## STAFF REPORT

SUBJECT: H-2021-0035 – TM Creek Apartments Phase 3

LOCATION: South of W. Franklin Rd. and east of S. Ten Mile Rd., in the NW ¼ of Section 14, Township 3N., Range 1W. (Parcel #R8483040240)

## C. Landscape Plan (dated: 5/3/21)

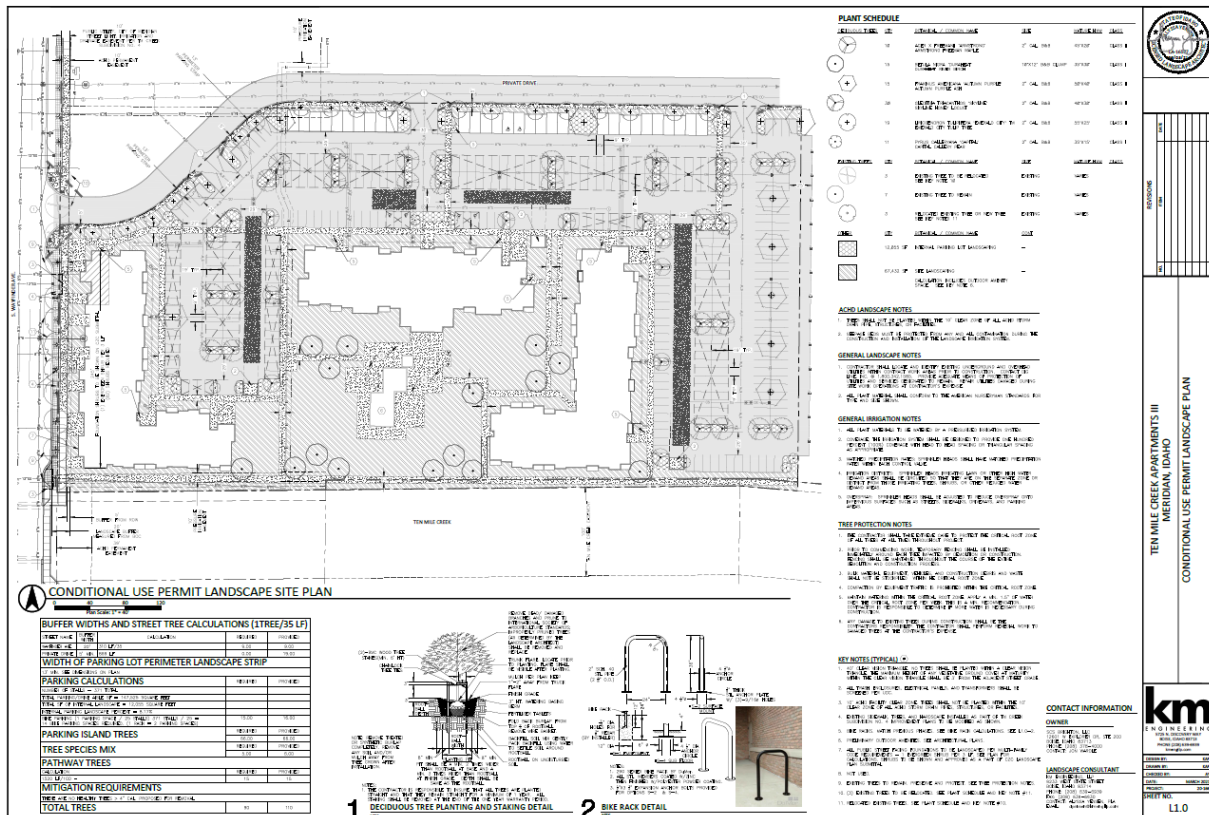
***The landscape plan submitted with the Certificate of Zoning Compliance application should depict landscaping along the street facing elevations adjacent to S. Wayfinder Ave. in accord with these standards.***

Landscaping is required to be provided along the pathway adjacent to the southern boundary of the site per the standards listed in UDC [11-3B-12C](#), which require a mix of trees, shrubs, lawn and/or other vegetative groundcover. **Landscaping should be added to the landscape plan in accord with this standard; calculations demonstrating compliance with this standard should also be included in the calculations table.**

Landscaping is required within common open space areas per the standards listed in UDC 11-3G-3E. **Calculations should be included in the calculations table demonstrating compliance with this standard.**

- c. Depict landscaping along the foundations of all street facing elevations adjacent to S. Wayfinder Ave. as set forth in UDC 11-4-3-27E.2.
  - d. Include a detail of the proposed site amenities.

- e. Depict a gate across the emergency access driveway from W. Franklin Rd. as required by the Fire Dept.
  - f. Depict landscaping along the pathway adjacent to the southern boundary of the site per the standards listed in UDC 11-3B-12C, which require a *mix* of trees, shrubs, lawn and/or other vegetative groundcover.

- g. Calculations should be included in the calculations table demonstrating compliance with the required landscaping in common open space areas per UDC 11-3G-3E.

### E. Conceptual Building Elevations & Renderings for Multi-Family Structures & Clubhouse

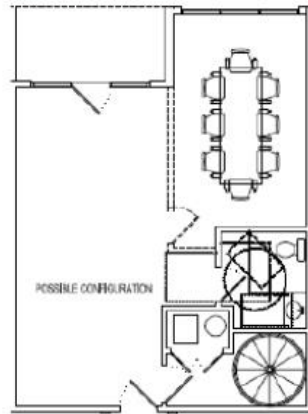
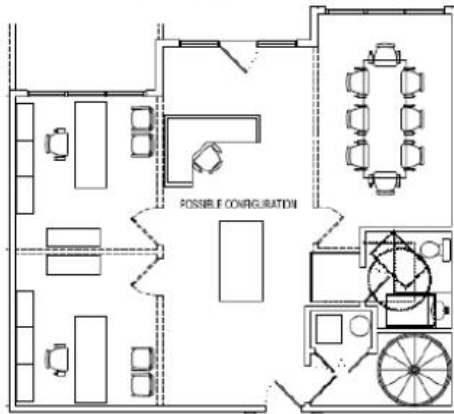
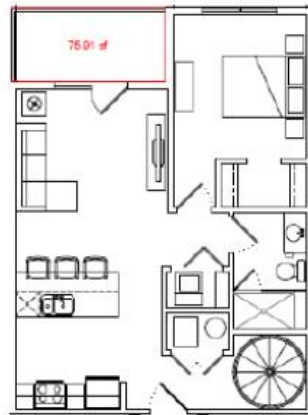
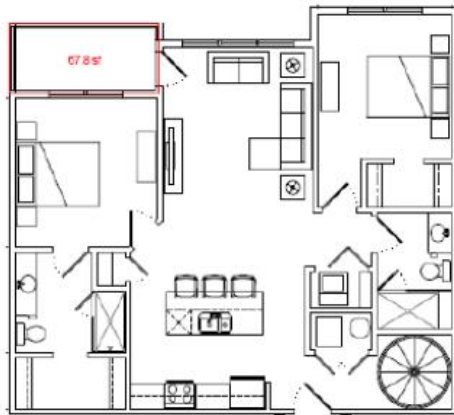
Conceptual building elevations were submitted for the proposed 4-story structures as shown in Section VIII.E. Building materials consist of stucco and bricks in neutral colors. Final design is required to comply with the adopted TM Crossing Design Guidelines.

**A Certificate of Zoning Compliance application shall be submitted and compliance with the TM Crossing design guidelines is required as set forth in the DA prior to submittal of building permit applications.**
